TCP/11/16(480) – 17/00618/FLL – Erection of a dwellinghouse on land 100 metres North West of Glendy Steading, Glenfarg

**TCP/11/16(480) – 17/00618/FLL – Erection of a
dwellinghouse on land 100 metres North West of Glendy
Steading, Glenfarg**

**PAPERS SUBMITTED
BY THE
APPLICANT**

NOTICE OF REVIEW

Viewpoint No.3

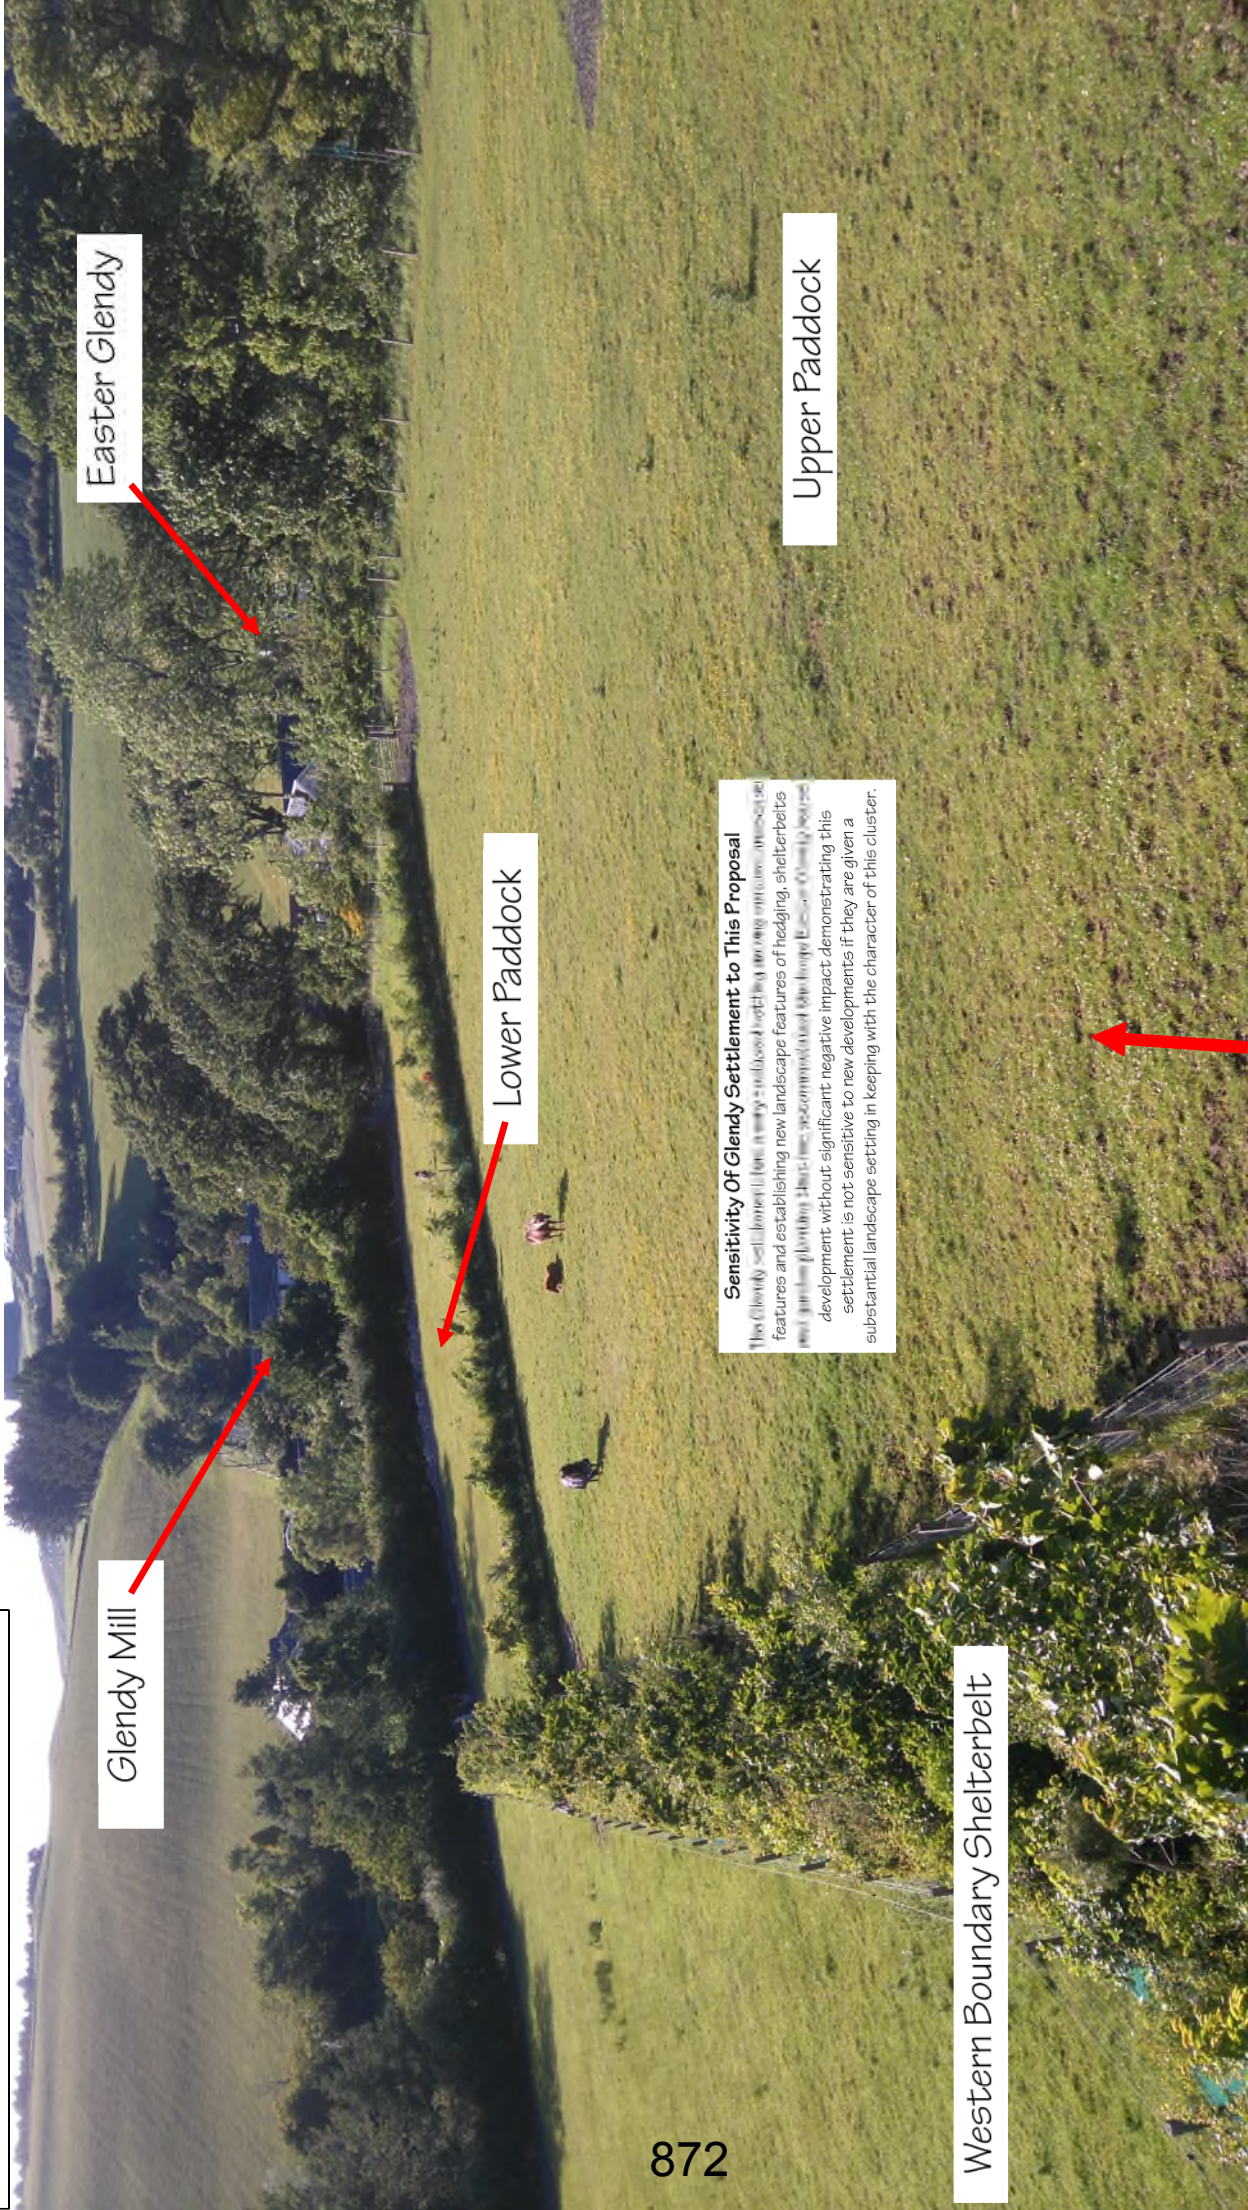
Photo 2: Similarly misidentifies Glendy Mill and fails to show the overlooking nature that the proposed site would have on the Mill and the other properties.

Photo 3: Similarly misidentifies Glendy Mill and fails to show the overlooking nature that the proposed site would have on the Mill and the other properties.

Viewpoint No.7

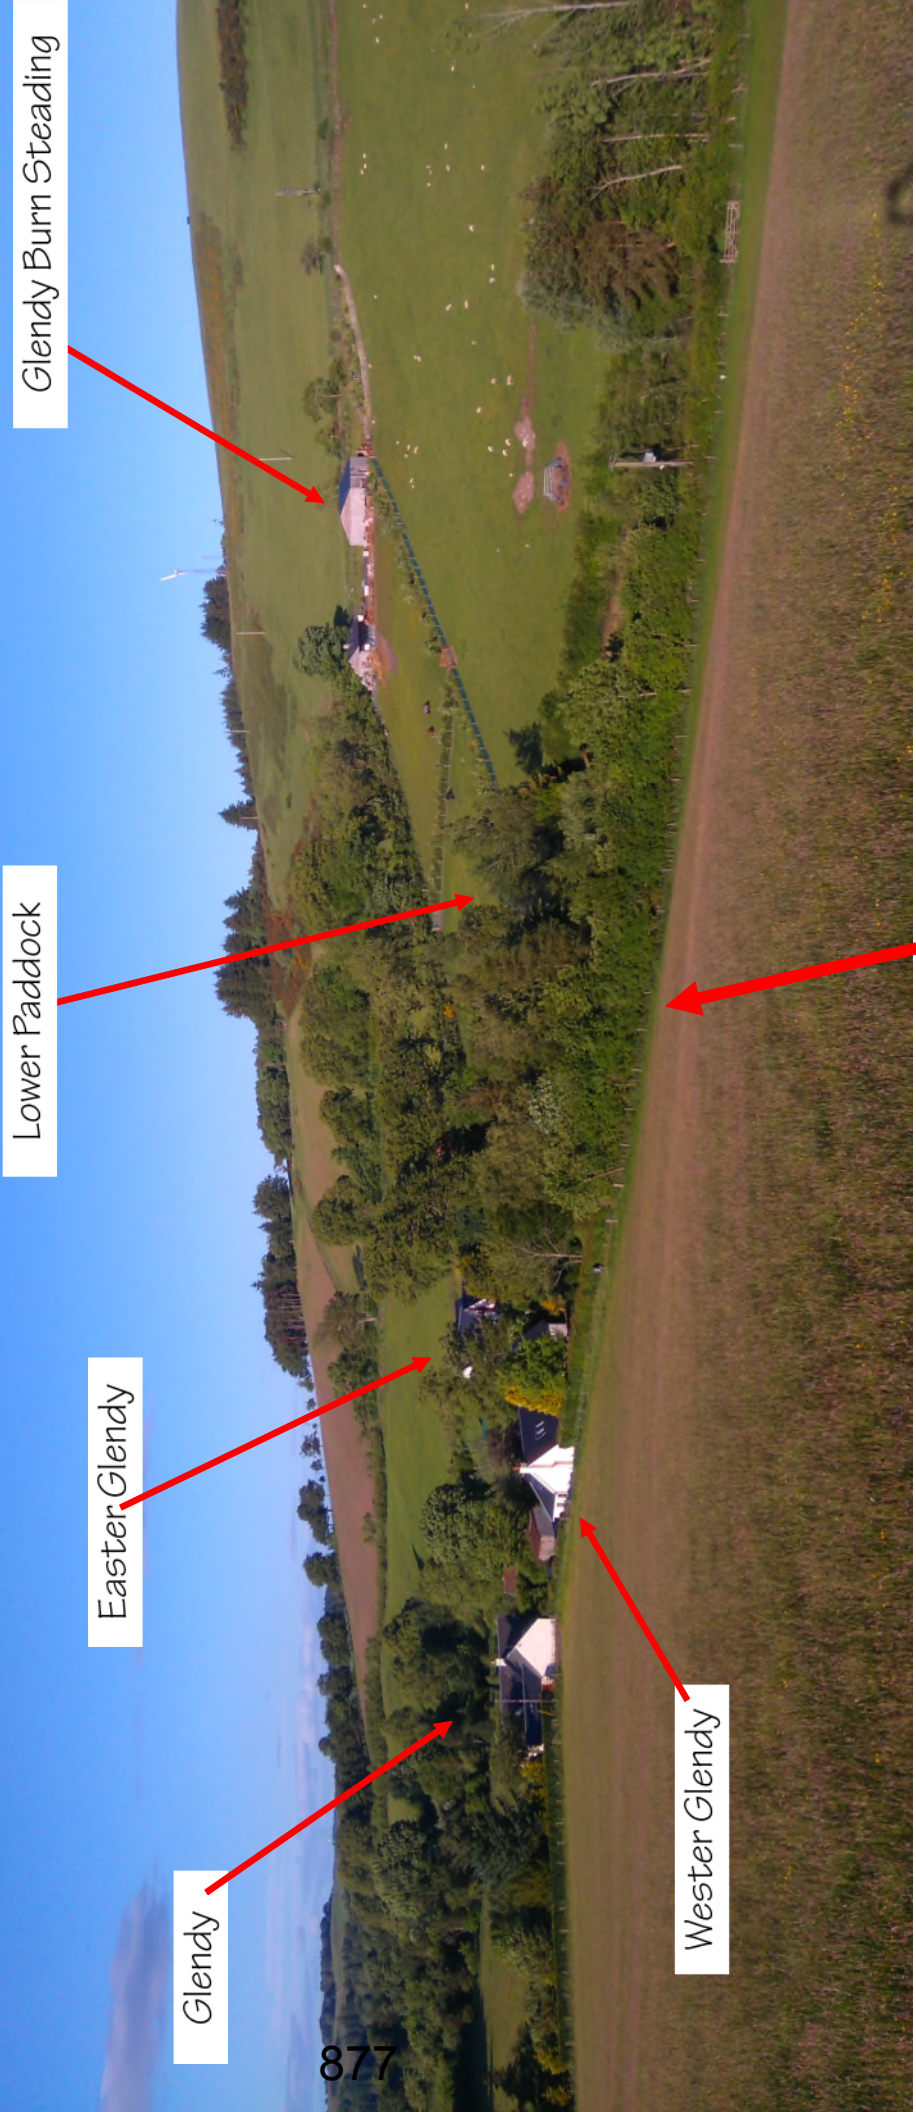
Photo 7: Fails to identify Glendy Mill at all and creates a misleading impression of the impact that the development would have. What it does show however is the elevated nature of the proposed site, the incongruous nature of a property that would overlook all the others and the, already discussed, lack of anything more than a recently created artificial boundary to both the east and south of the site.
